NOTICE OF DECISION

Application for a Geologic Hazards Permit

Case File:	T2-2026-0031	**Applicant**:	Lydia Peters
Proposal:	Request for a Geologic Hazards (GH) permit to construct a replacement single-family dwelling. An accessory building is noted as "proposed" on the applicant's site plan, but was not evaluated through this permit review because it is not located within the Geologic Hazards overlay.

Location:	21501 NW Beck Road, Portland	**Property ID #** R325811
	Map, Tax lot: 2N2W23B -00600	**Alt. Acct. #** R972230090
Base Zone:	Rural Residential (RR)	
Overlays:	Significant Wildlife Habitats (SEC-h), Geologic Hazards (GH)

Exhibit A.2 - Site Plan

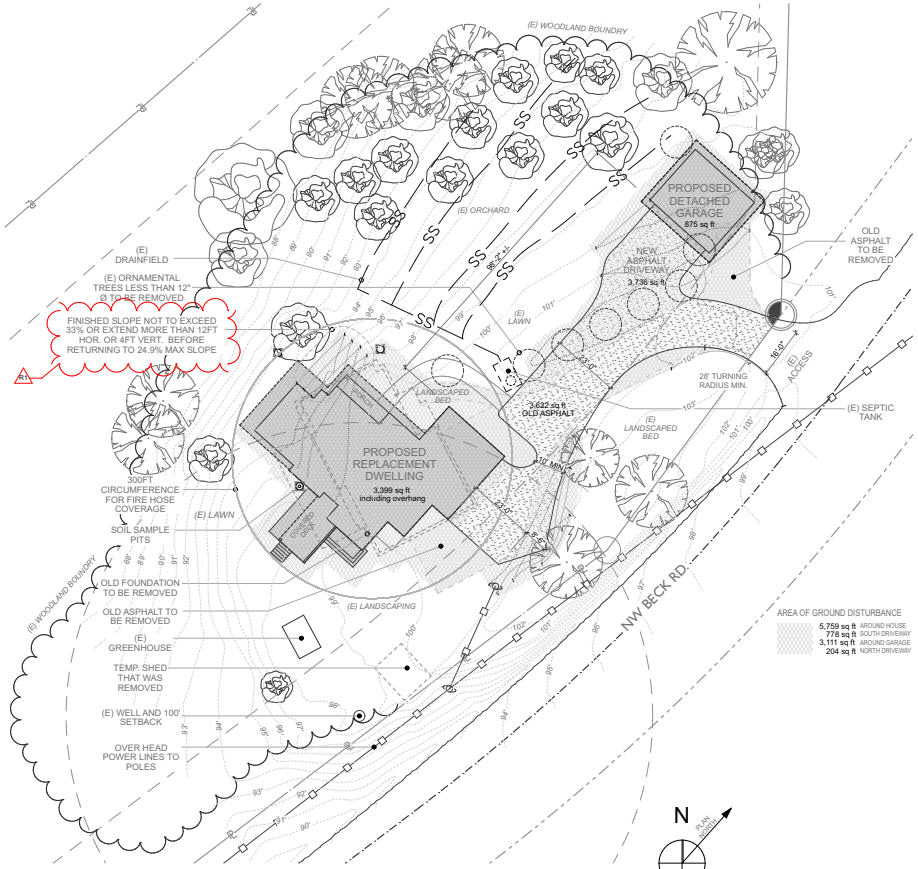
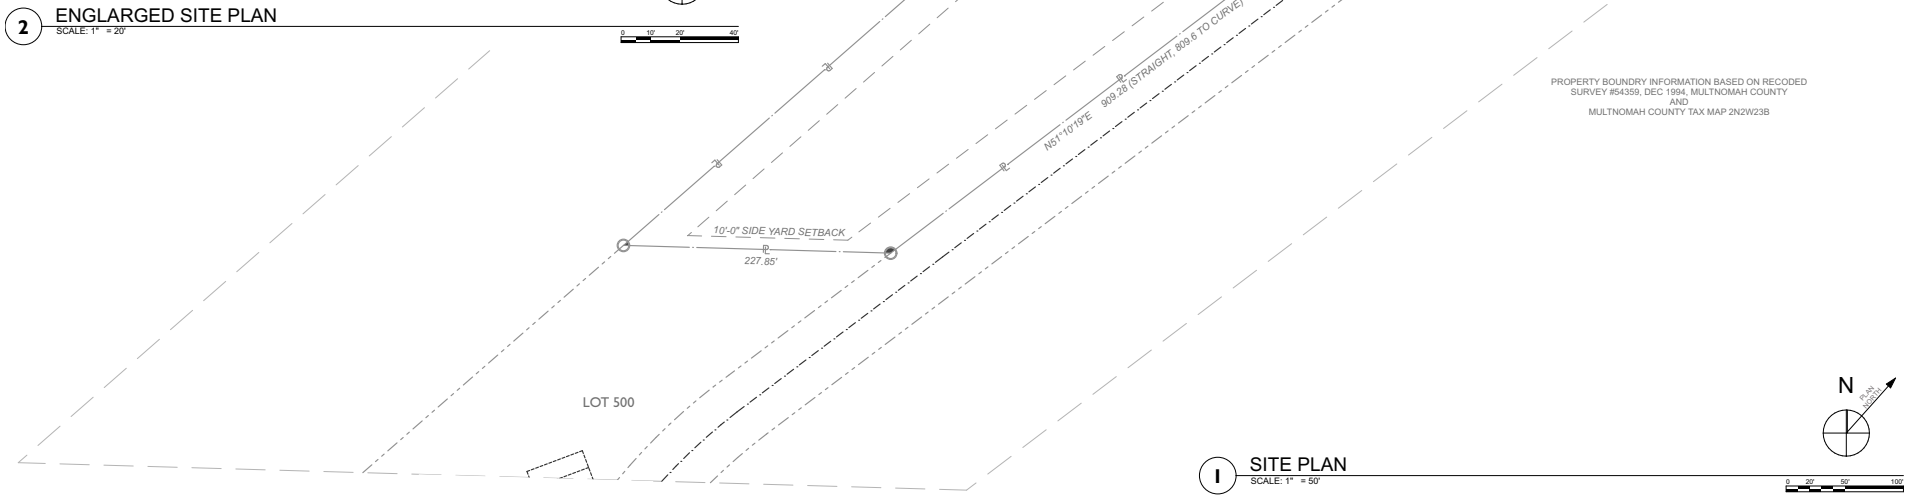
Staff: The commenters expressed concerns about the proximity of the proposed detached garage to the east shared side property line, and the accuracy of the information shown on the site plan relative to a recent survey that was completed for the property, and markers that were placed on the property line. In response, staff reached out to the applicant and requested a copy of that survey. The applicant provided a copy of the survey (Exhibit A.8) and indicated that it was the basis for all provided site drawings. Staff reviewed the applicant's site plan (Exhibit A.2) and the 2025 survey (Exhibit A.8), and confirmed that benchmarks from the 2025 are accurately reflected on the applicant's site plan. Finally, since the proposed detached garage is not subject to Type II Geologic Hazards review, which is the scope of this decision, setbacks for the detached garage were not evaluated in this report, and will be verified by Land Use Planning staff during Zoning Plan Review.

Staff: The site plan shows the dwelling meets the minimum yard standards. The dwelling is more than 30 feet from all property lines (Exhibit A.2). The applicant did not provide a plan showing the elevation of the dwelling. A condition will be required that final designs be reviewed by planning staff at the time of zoning Plan Review. *As conditioned, criteria met.*

Staff: A note on the applicant's site plan indicates that no cut and fill slopes will exceed 33% on the site, and states that the maximum finished slopes will be approximately 25% (Exhibit A.2). *Criterion met.*

d. Submit a final ground disturbance plan stamped by a Geotechnical Engineer that includes the following information:
        i. The anticipated quantities of cut and fill (including structural fill to support the proposed dwelling) that will be deposited on site, or a statement that indicates that no fill, including the "imported granular fill" identified in the geotechnical report (Exhibit A.4) will be imported to the site. [MCC 39.5085, MCC 39.5090(A), (B)]
        ii. The location and height of all finished cut and fill slopes [MCC 39.5085(A), MCC 39.5090(C), (D)]
        iii. Details of permanent stabilization methods (landscaping/planting) that will be employed to stabilize disturbed areas [MCC 39.5090(L)]
        iv. An approximate project timeline indicating the anticipated ground disturbance schedule – identify any phased grading of areas on the site and timelines for temporary and permanent stabilization. [MCC 39.5090(H), (L)]
